Docket Item # 3
BAR CASE #2016-0132

BAR Meeting
May 18, 2016

ISSUE: Certificate of Appropriateness - Alterations

LOCATION: 820 Duke Street

SIDING PROPOSAL

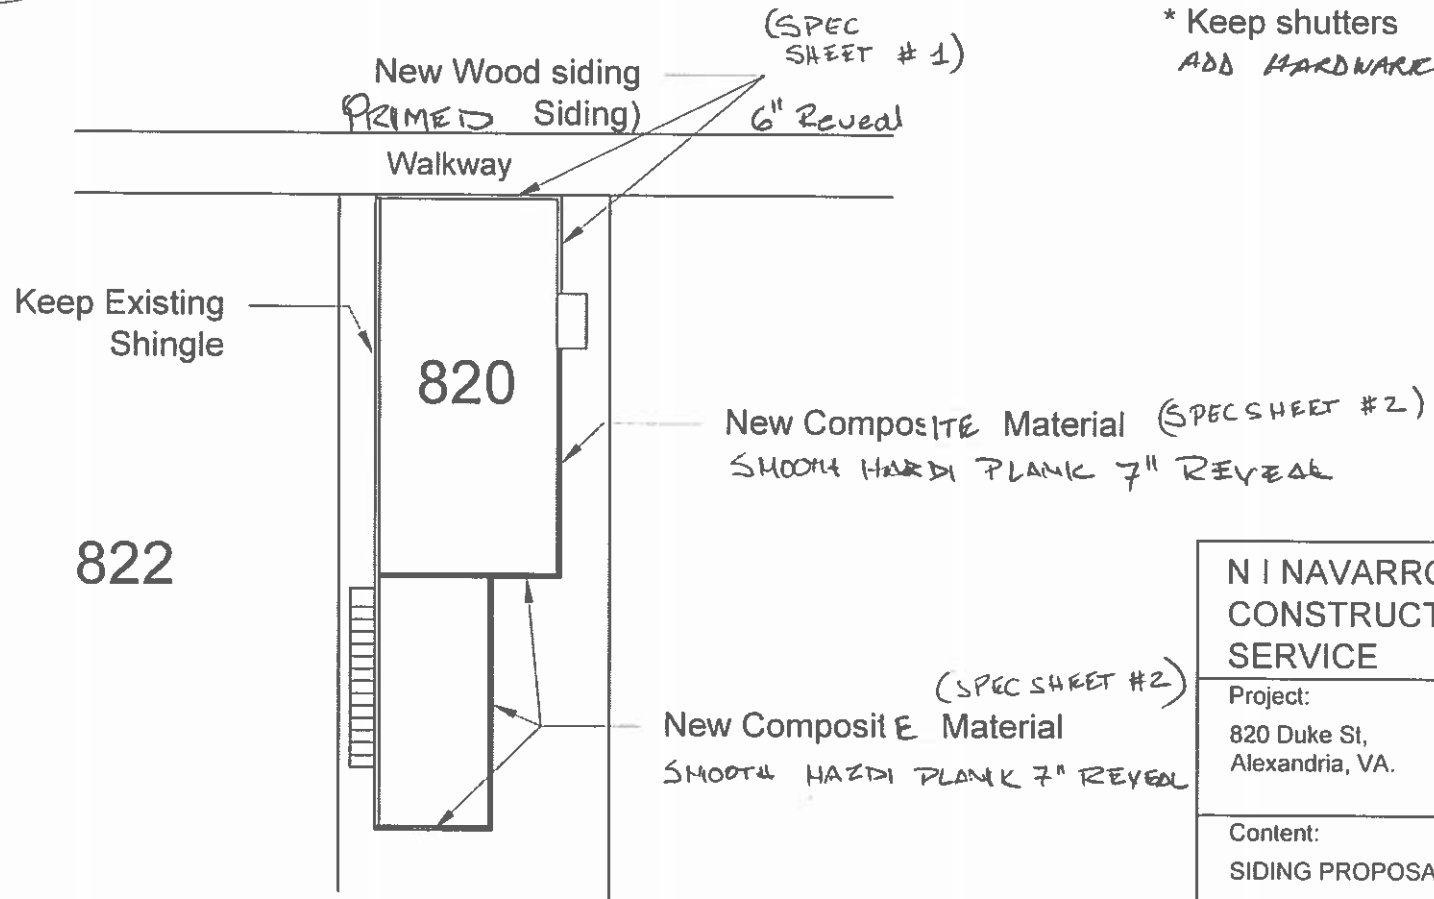
All existing siding on the building, with the exception of the west elevation adjacent to 822 Duke Street, will be replaced. On the front façade and the east elevation in front of the existing chimney, new wood clapboard siding with either an 8” or 6” exposure will be installed. The remainder of the east elevation of the main block and the rear elevations will have smooth fiber cement clapboard siding with a 7” exposure.

Staff supports the installation of the new wood siding on the front façade and the east elevation in front of the chimney where it is visible from the public way. Staff could find no record for Board approval of the wood siding currently on the main block of the house, which is in poor condition and is in need of replacement. The 1939 building permit references early weatherboard siding, which was removed, so the proposed siding is appropriate in both style and material.

Although the Board’s policy does not recommend fiber cement siding on buildings or additions constructed prior to the mid-1970s, we know that these two rear additions were never clad with wood siding but rather materials which were considered “modern” at the time, first Bricktex and then Masonite siding (although brick was specified). Therefore, Staff supports the installation of fiber cement siding in this particular location. The rear of the house is setback 40’ or more from the rear property line making it difficult, if not impossible, for the general public to identify the cladding material. Staff’s only concern is that the wood siding on the front and the fiber cement siding on the rear have the same profile, and recommends a consistent 6” exposure to weather.

1. all of the replacement windows have Low-E 272 glass, not the proposed Low-E 366 glass;
2. the six-over-six replacement windows have 7/8" muntins and not the proposed 1 1/8" muntins; and,
3. both the wood and fiber cement clapboard siding have a matching, approximately 6" exposure.

WINDOW SCOPE OF WORK

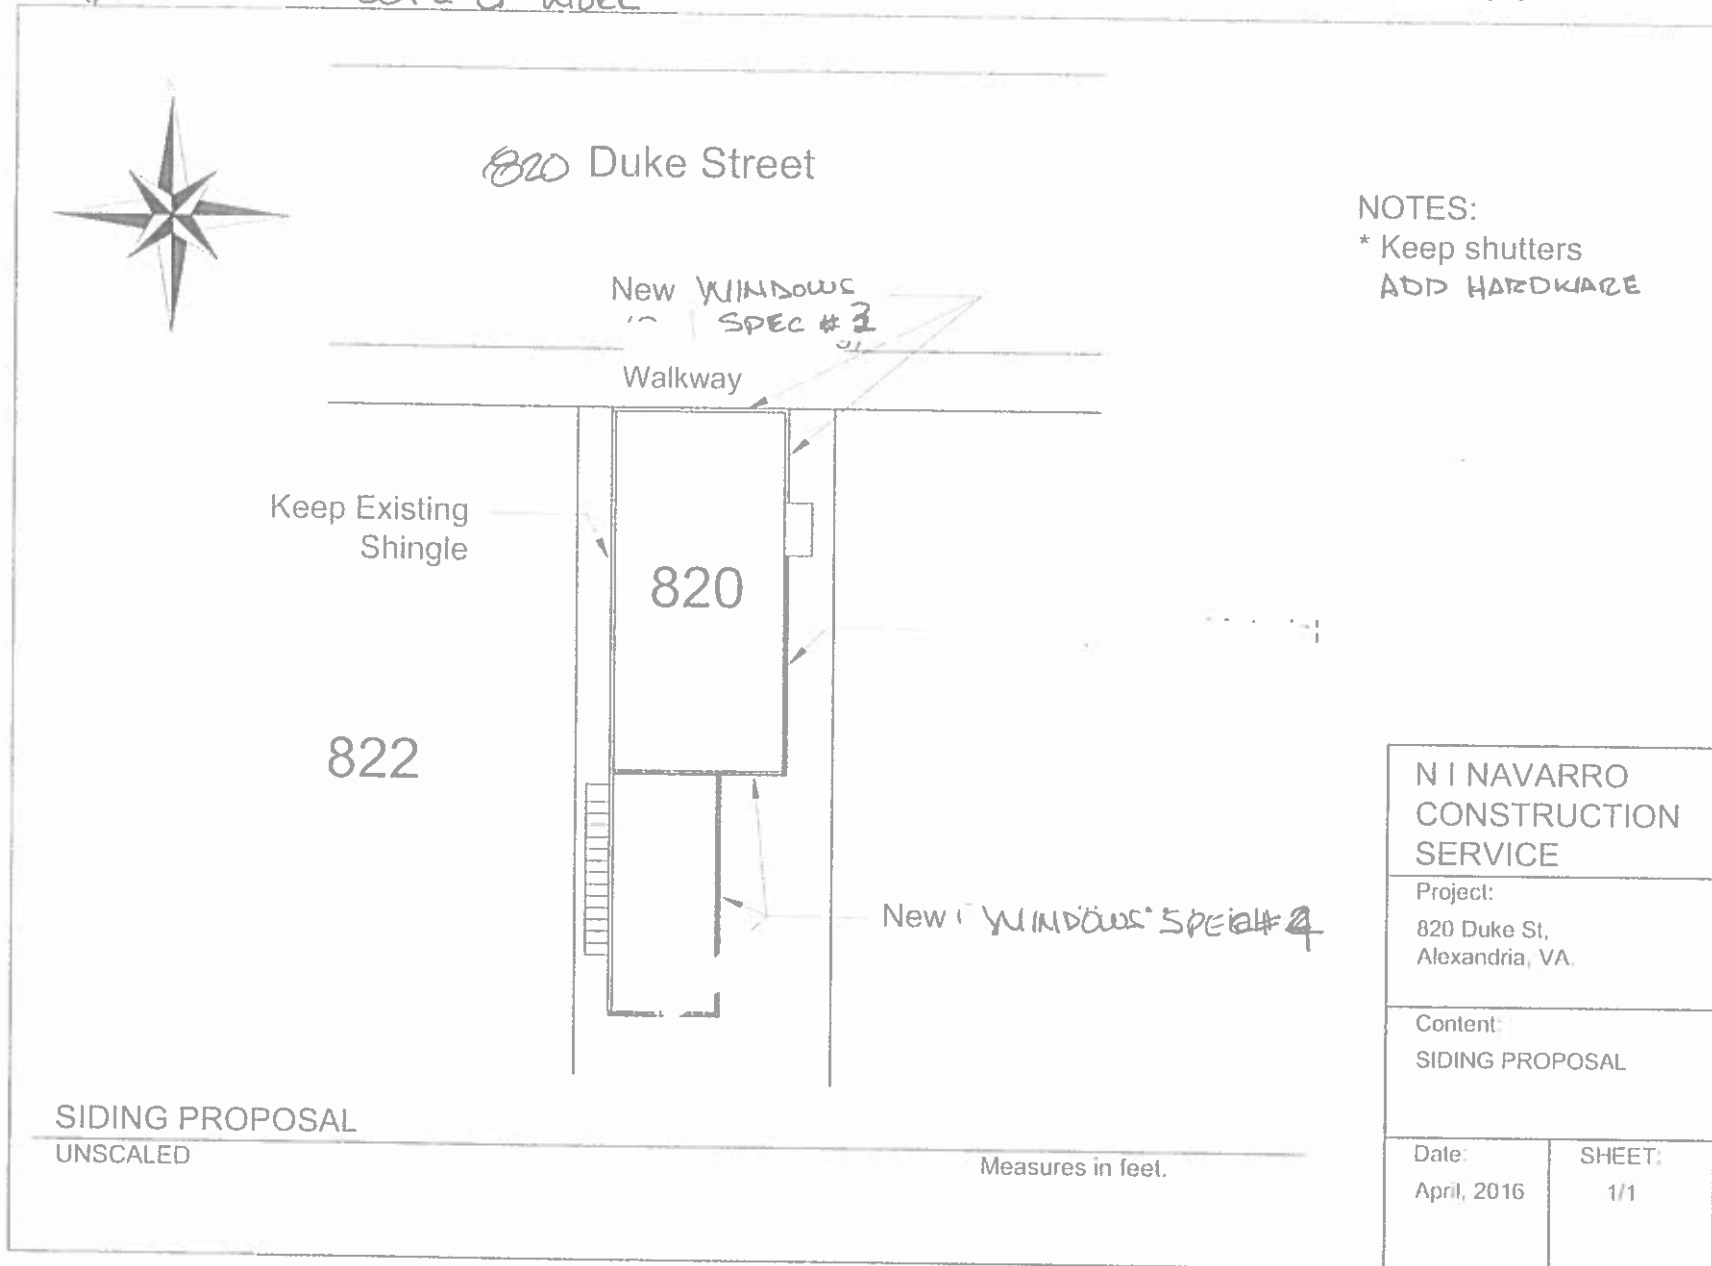
The applicant proposes to replace the three, two-over-two windows on the front façade with two-over-two, simulated divided light (SDL) wood windows with 1 1/8” putty profile muntins. On the rear, the applicant proposes to replace the majority of the existing wood windows with six-over-six SDL wood windows with 1 1/8” muntins. All windows will have Low-E 366 glass.

Likewise, Staff has no objection to the installation of replacement wood SDL windows on the house because no historic windows exist, which is not surprising given the multiple modifications to the building since its construction. The Board’s *Window Policy* allows for the installation of SDL windows in one-over-one and two-over-two windows on the front façade, and SDL windows on secondary elevations in any light configuration. Furthermore, the Board has already approved SDL wood windows in the rear of the building in 1999. Two elements of the proposed windows that do not comply with the *Alexandria Replacement Window Performance Specifications*: the type of glass specified (LoE-366 instead of LoE-272) and the use of 1 1/8” wide muntins on the six-over-six windows. Staff recommends that the window specifications be modified to reflect the more transparent and less reflective LoE-272 glass and that the muntins on the six-over-six windows be change to 7/8”, which is consistent with historic window muntins.
